ML4000 TB to aux mod.

ODD GROUP PCB (1,3,5,7) AG4208 issue 5

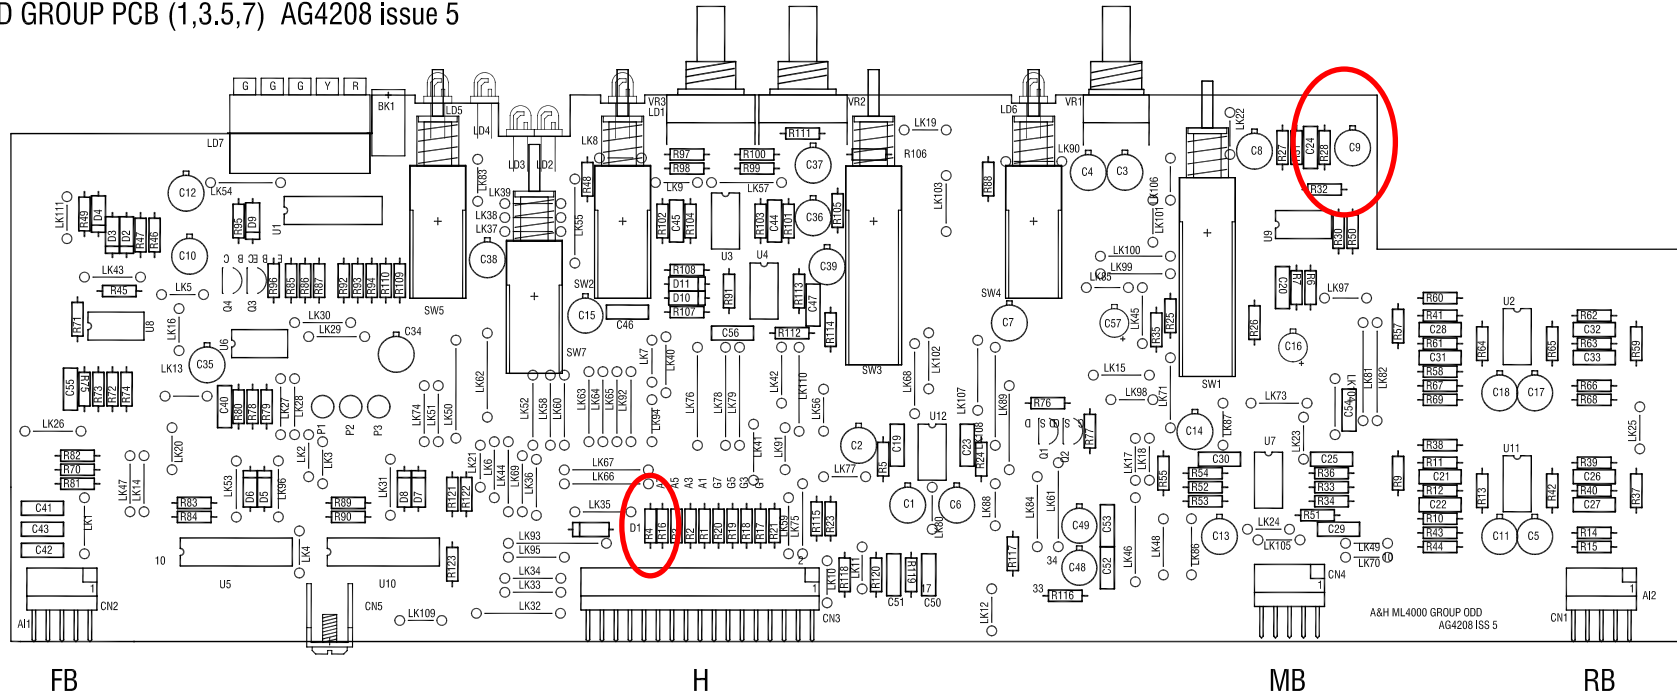
Link the C1 side of R4 to the C8 side of R28 via a 15kOhm resistor in series.

This mod will allow talkback to aux only when auxs are routed to the rotary controls.
